**Government of Telangana
Forest Department**

Sub: TS - Forest Department F (C) 1980- Diversion of 2.121 Ha of Forest land for formation of approach road for construction of HLB across Manjeera Riyer from Dharmareddy to Muddapur (Via) Venkampally road PR Road in Kamareddy District in favour of Executive Engineer, R&B Division Kamareddy- EDS raised by IRO , Hyderabad - Report submitted- Reg.

GOVERNMENT OF TELANGANA
ROADS AND BUILDINGS DEPARTMENT

Sub: Diversion of 2.121 Ha of Forest land for formation approach road construction of HLB across Manjeera River from Dharmareddy to Muddapur via Venkampally road PR road in Kamareddy district in favour of Executive Engineer (R&B) Division Kamareddy –EDS raised by IRO Hyderabad- submission of reply- reg.

Encl.: Maps-(2 sets)

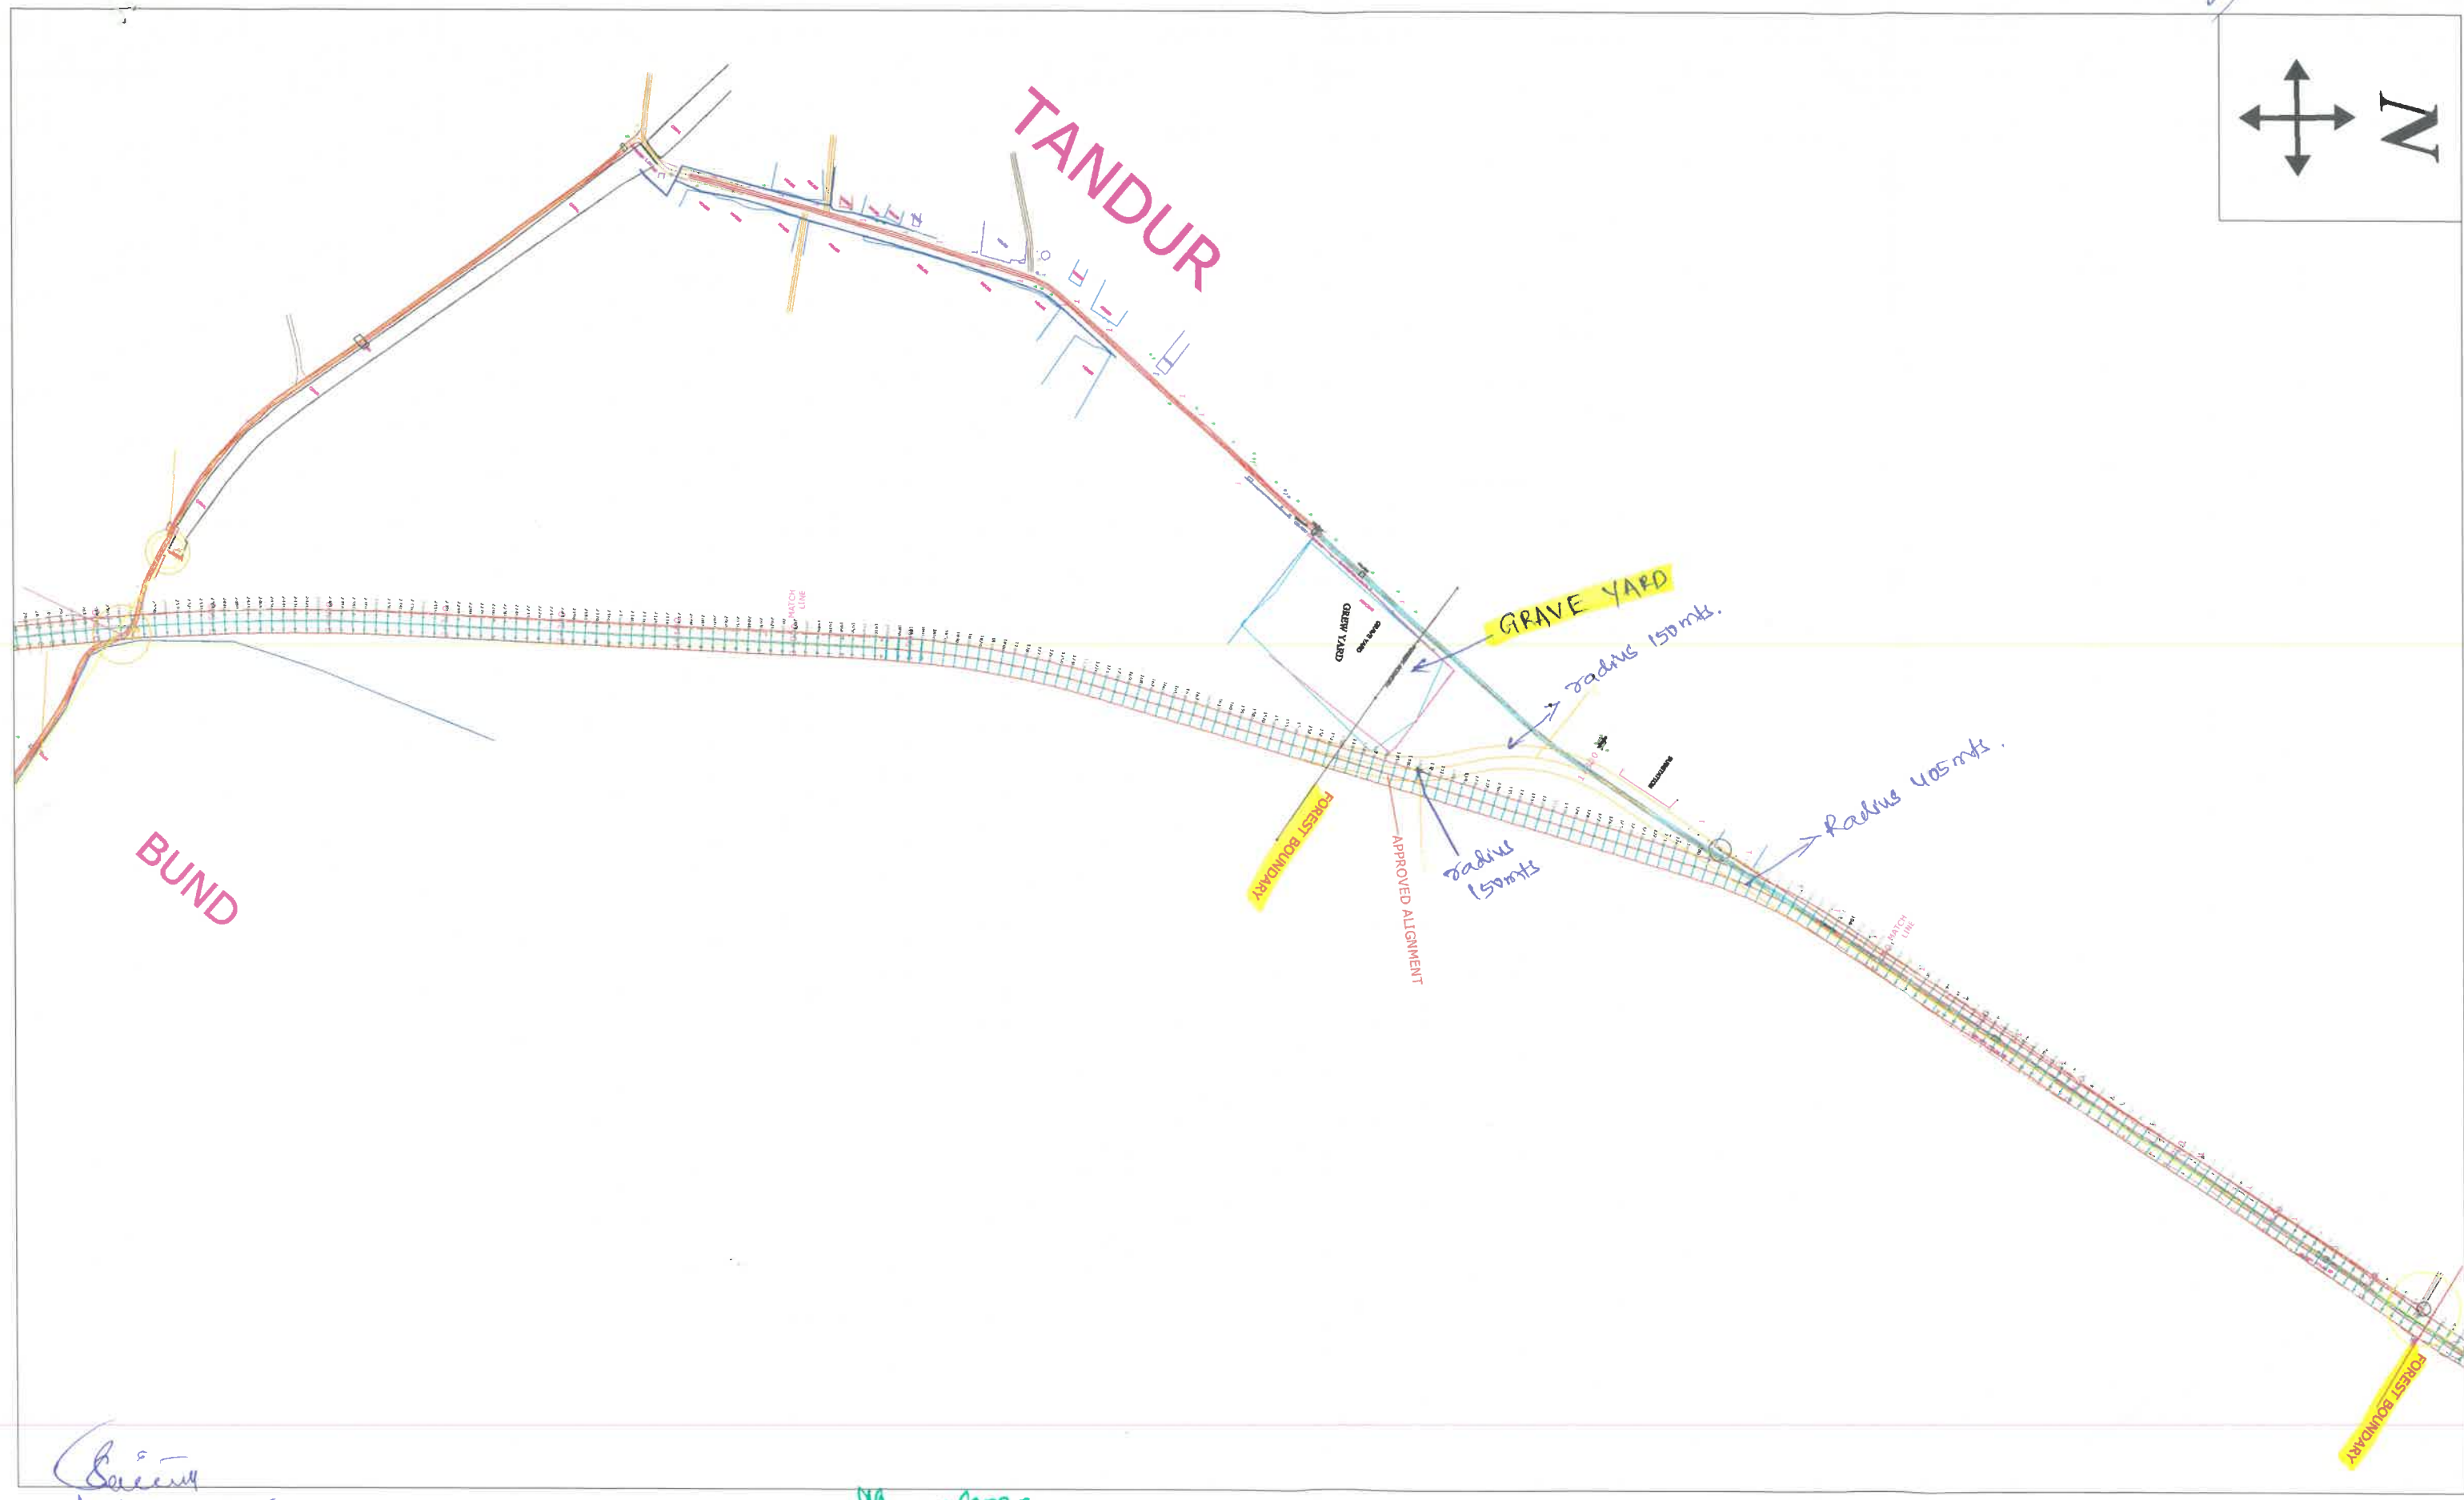
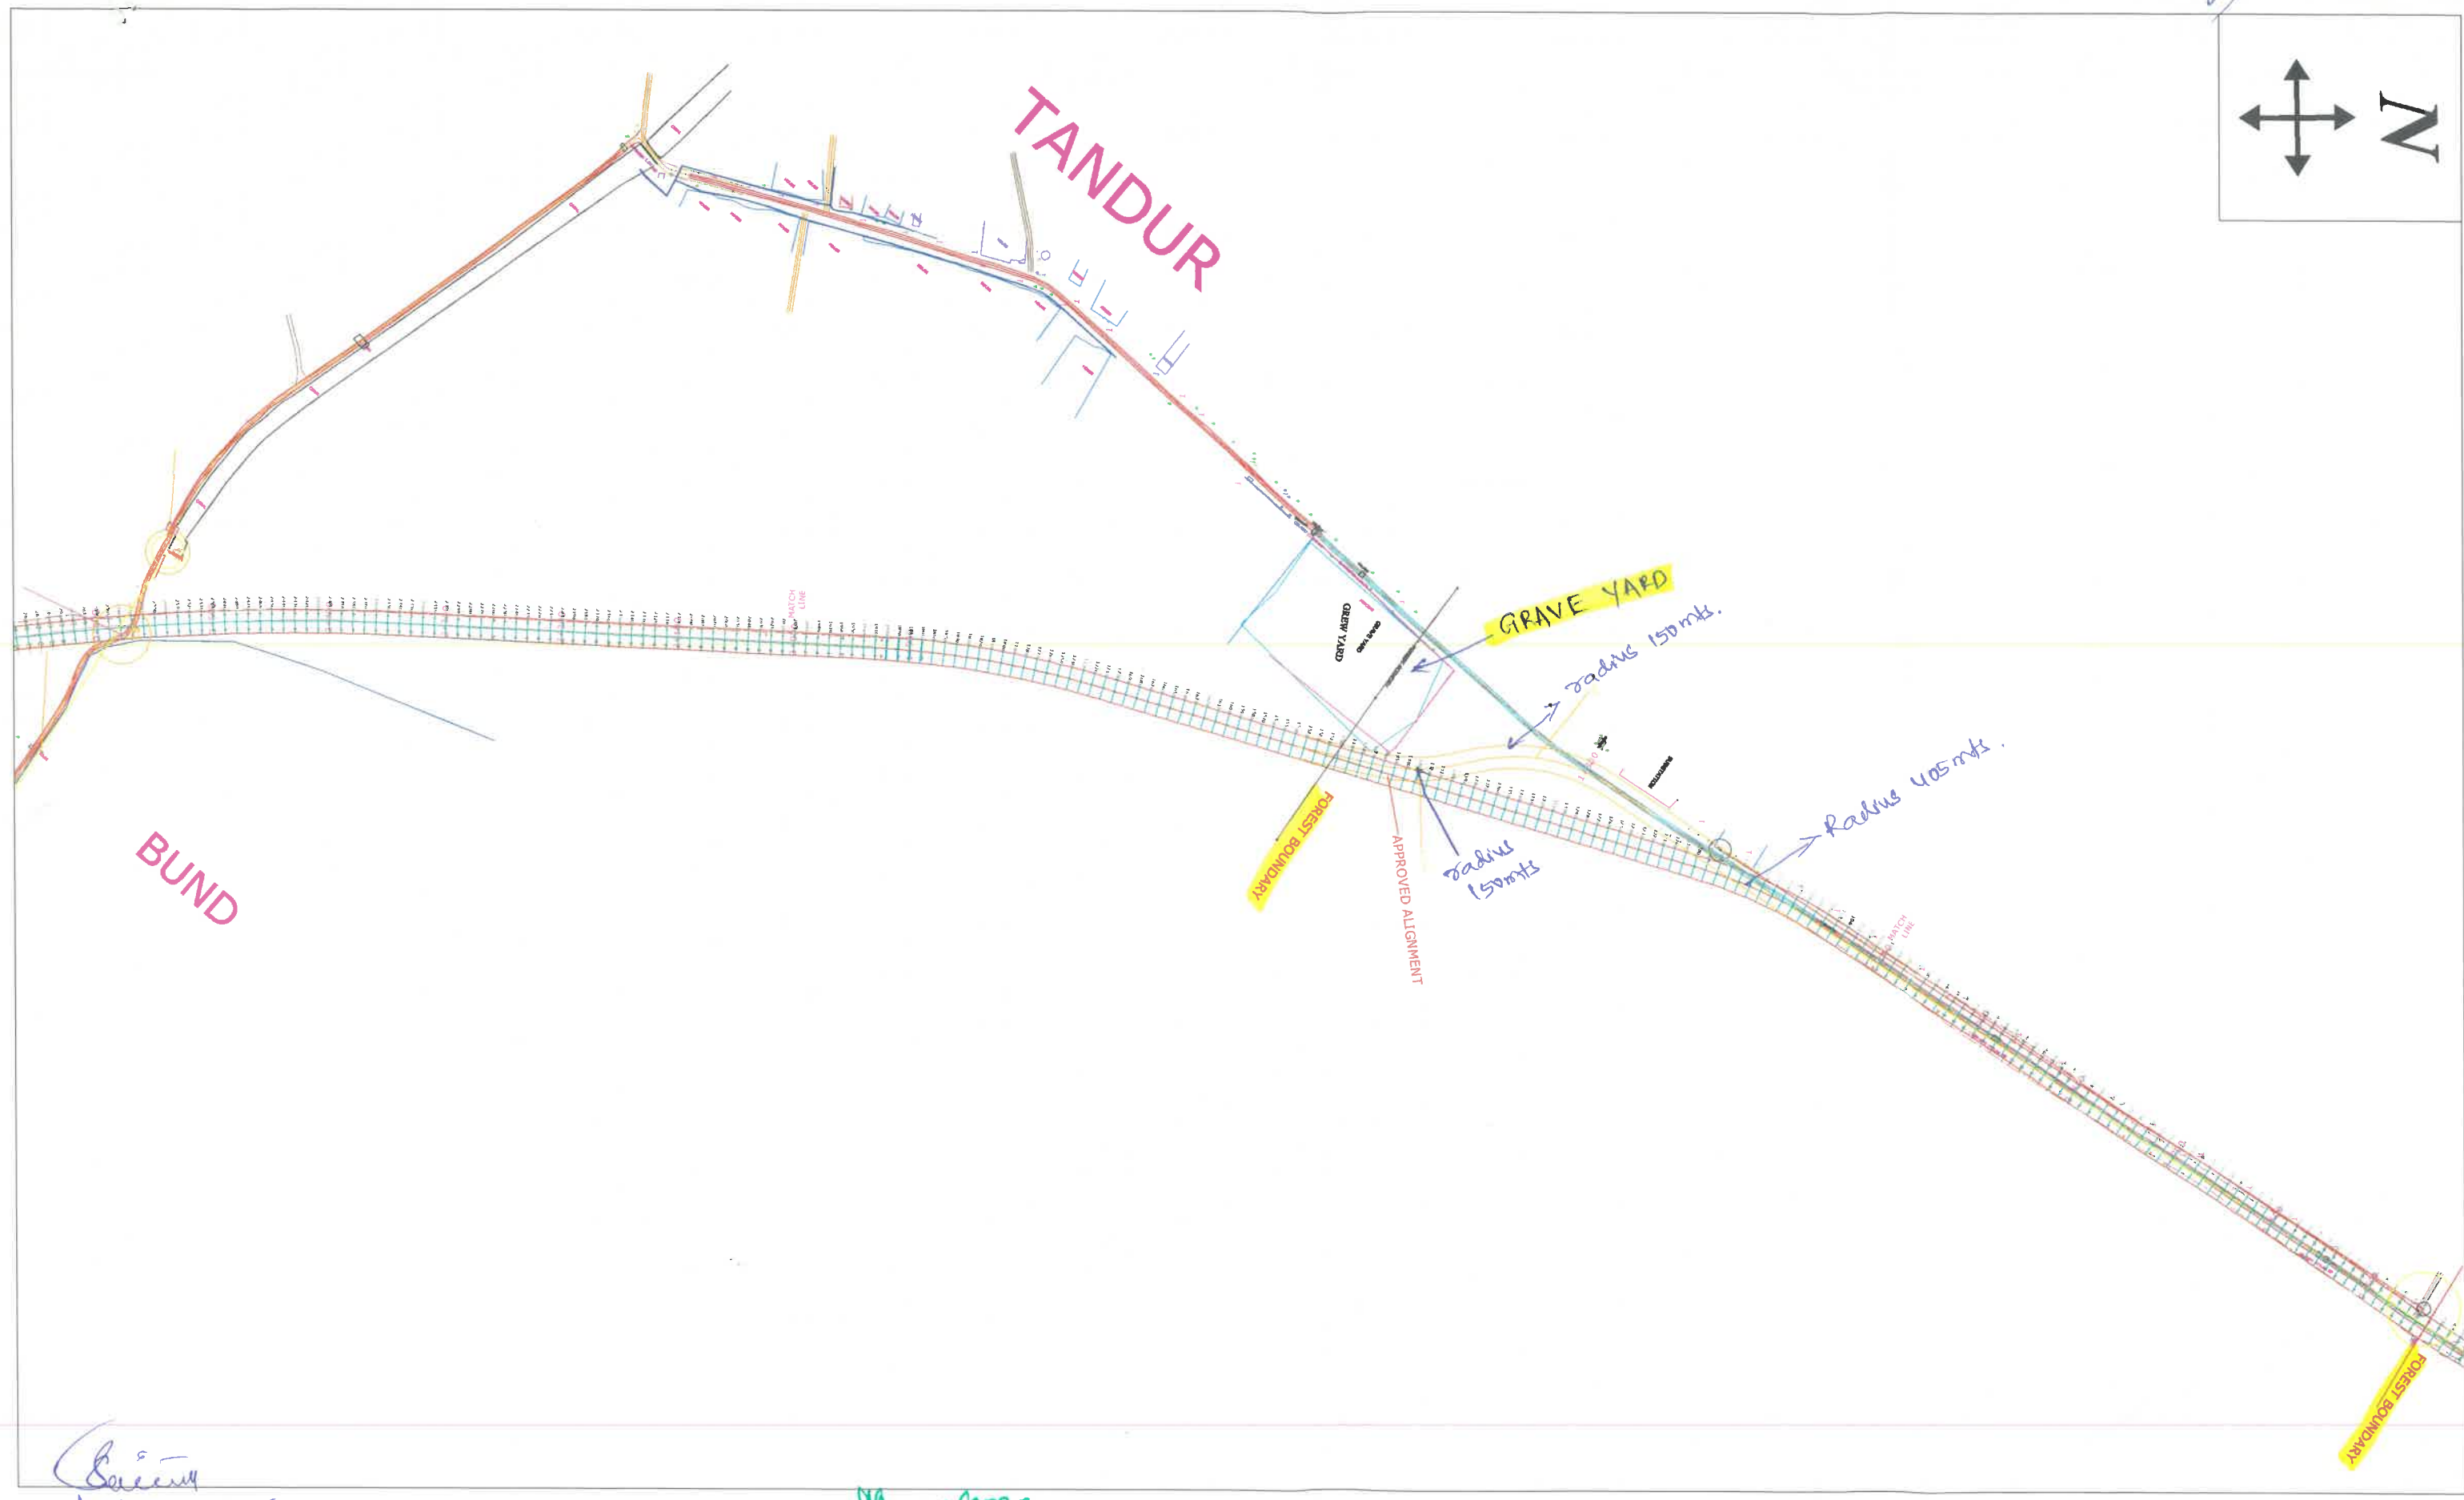
Hyderabad has directed to realign the road along the boundary of the forest land.

Accordingly resurvey was conducted and it is found that the realignment is not possible due to following reasons.

- i) Presence of grave yard and in continuation houses of Tandoor village.
- ii) This road connects two National highways i.e. Hydearbad-Medak-Bodhan road (NH.765D) and Sanagareddy-Nanded-Akola road (NH161). Hence, the minimum radius desired is 400meters in accordance Indian road congress code IRC SP 84-2014.
- iii) If we try to use existing road to the extent possible, we have to introduce curves which are less than 400m radius. By introducing the S curve the road is prone to accidents.

Hence , it is not possible to realign the road. However the proposed alignment was proposed duly using the maximum extent of the existing road on the forest land (i.e.from km.0/450 to 1/100) and deviating from the existing road with radius 405m and just abutting the grave yard.
